**Errata Sheet for Environmental Assessment Titled  
Restore Saugus River Turning Basin and Dock  
Saugus Iron Works National Historic Site**

## Public and Interagency Comments and Responses to Environmental Assessment

DRAWING NO. <b>41,006</b>	SHEET NO. <b>18</b>	TOTAL SHEETS <b>20</b>
SECTION CUT KEY PLAN		
SAVING ROCK WORKS, INC.		
DATE <b>JAN 2007</b>	C15	TITLE OF DRAWING <b>SECTION CUT KEY PLAN</b>

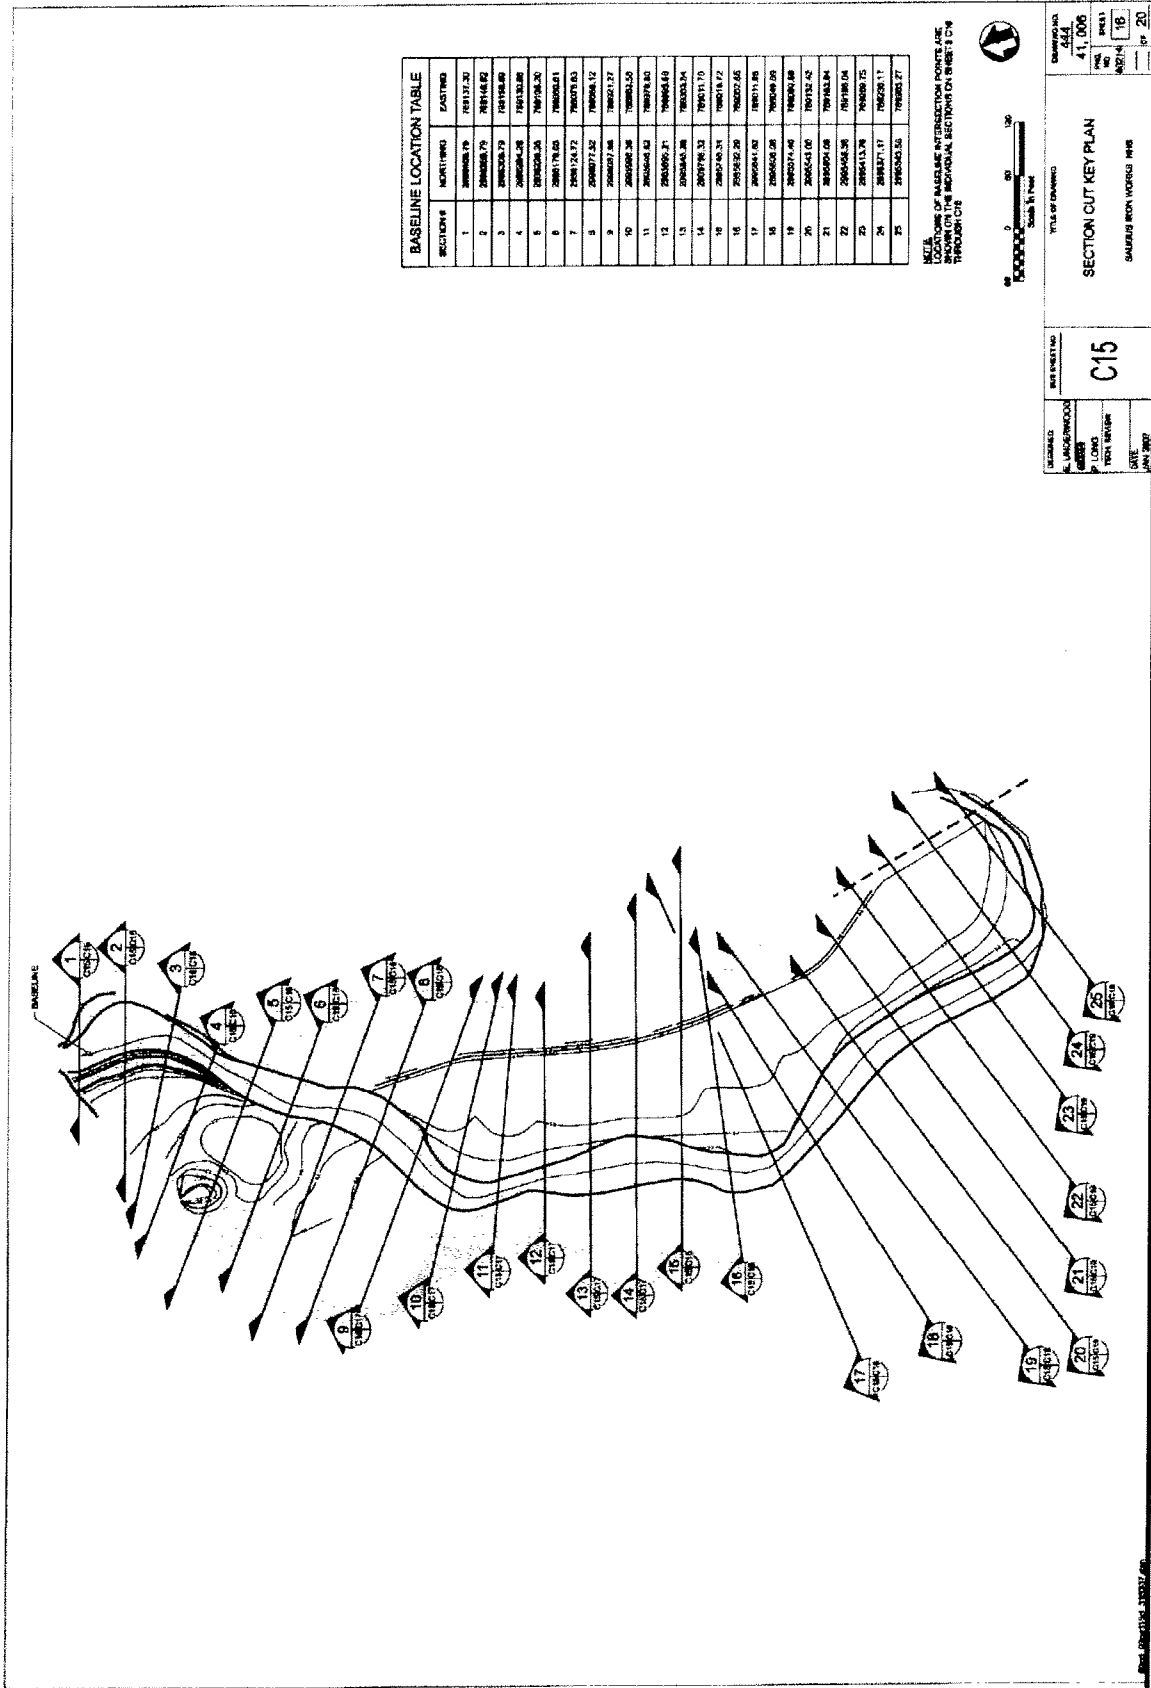
- 8) Appendix L of the EA/DEIR contains Draft Construction Documents for the project. Several of the draft construction drawings were not updated at the time the EA/DEIR was published. The affected sheets include C-6, C-7, C-8, C-15, and C-16. The length and height of the gravel/cobble berm depicted on these sheets was increased during stakeholder discussions to protect rainbow smelt spawning habitat in the Saugus River and maintain the integrity of the river channel adjacent to the project site. The drawings (Pages A-3–A-7) have been updated so that all the sheets accurately reflect these design changes. The change in the construction drawings will neither result in changes to the preferred alternative nor impacts to environmental resources different from those analyzed in the Environmental Assessment/Draft Environmental Impact Report.

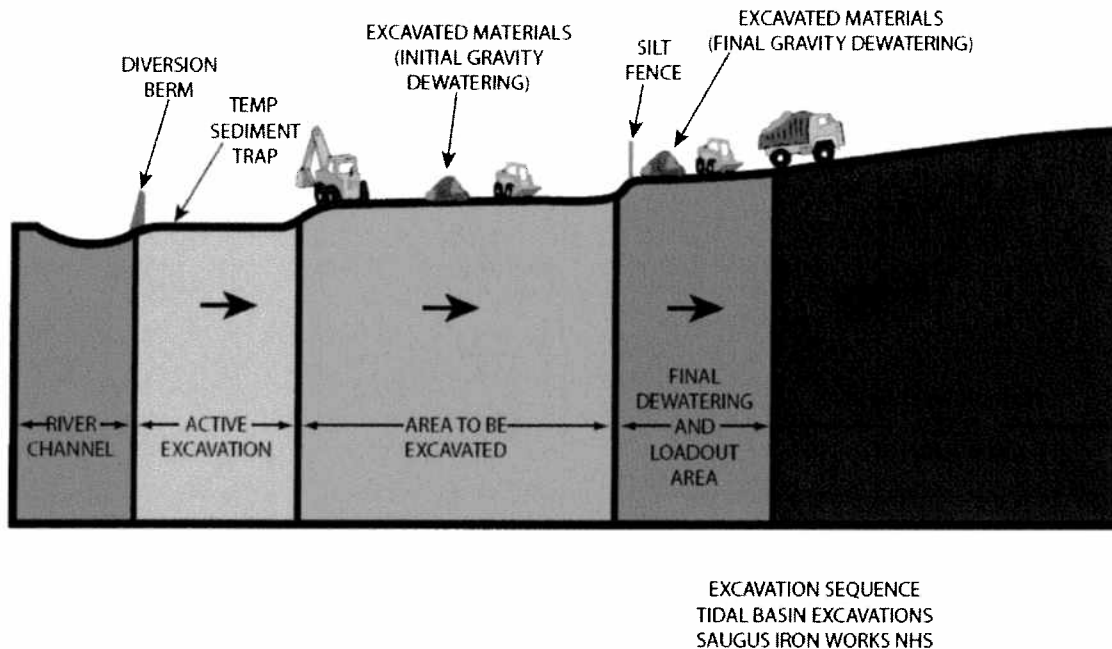
**DEP – 6:** *Generally, more attention should be given in the planning process to phasing the work schedule, dredge methodology, spoil handling, and effluent treatment than is evident from a review of the document in order to ensure that the environmental impacts are avoided and reduced. MassDEP recommends that the NPS select the combination of options that minimizes impacts the greatest extent. However, the final selection of dredging methods and mitigation measures for erosion and sedimentation controls may need to be made during permitting of a Water Quality Certificate, in order to take into consideration the results of additional sampling data that will be collected subsequent to the DETR.*

*Lastly, it appears from the DEIR that the cost differential among the erosion and sedimentation control measures could be a driving factor in the selection of techniques. Areas with higher contamination levels may need more elaborate and potentially more expensive erosion and sediment controls to prevent the release of contaminated sediment into the river than other areas. It should be possible to develop a staged dredging sequencing plan, possibly with intermediate settling basins, native soil berms, or other management techniques that do not require expensive control materials, to minimize the release of contaminated sediments. A well conceived and sequenced plan would help to ensure that the project is cost-effective.*

**Response:** A primary criterion from the beginning of the project has been minimization of disturbances outside the specified work areas due to ecologically sensitive areas within the Saugus River channel. As a result, access and operational areas were designed to use, to the extent possible, existing access trails, minimize disturbance to existing vegetation, and eliminate entirely any access or work within or across the Saugus River.

The project team considered conventional dredging and excavation with conventional excavation equipment. Conventional dredging was determined to be inappropriate at this site since, even with sediment removal to the specified limits, there is generally insufficient standing water to float a conventional dredge. In addition, there are no areas, either on the site, nor adjacent to the site, to install dewatering facilities necessary to dewater liquid dredge spoils.

The preferred method of removal is sediment excavation by conventional excavation practices with modifications to accommodate materials dewatering and control of potentially-impacted water within the excavation. A schematic showing the major components and sequence of the excavation and materials handling process are shown in the illustration below. These components include:

- Diversion of storm and tidal water around the work area (as described above),
- Excavation with conventional construction equipment,
- Initial and final materials dewatering areas within containment area, and
- Water containment and sediment controls.

Water collecting within the work area would include ponded water within the excavation, storm water, and water from excavated sediment dewatering. It would be allowed to accumulate within the sediment trap areas for initial suspended solids removal. The accumulated water would then be pumped from a sump pit within the sediment traps and then through geotextile filter bags to remove remaining suspended solids prior to discharge into the Saugus River.
